Product Change Notification

Product Line:	powerCON TRUE1	Part No:	NAC3FX-W NAC3MX-W NAC3FPX-ST
Piece Part:	screws	Part No:	-
Engineering Change Request:	78-2014	Date:	13.11.2014
Engineering Change Execution:	Peter Mario	Date:	09.12.2014
Comments:	Changed color of the screws (L, N)

Affected products:	NAC3FX-W, NAC3MX-W, NAC3FPX-ST
--------------------	--------------------------------

NAC3MX-W

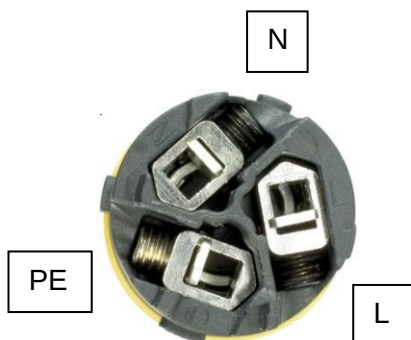
We have changed the color of the L & N contact screws of the cable connector inserts from nickel to black. The screw of the groundcontact remains as is.

NAC3FPX-ST

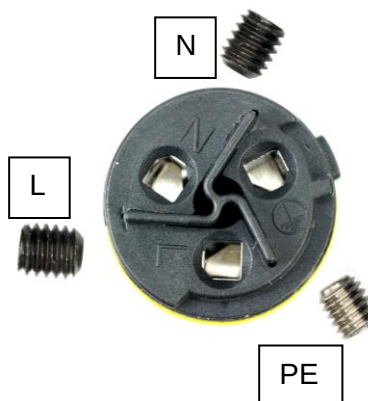
All 3 screws of the chassis connector are changed from nickel to black.
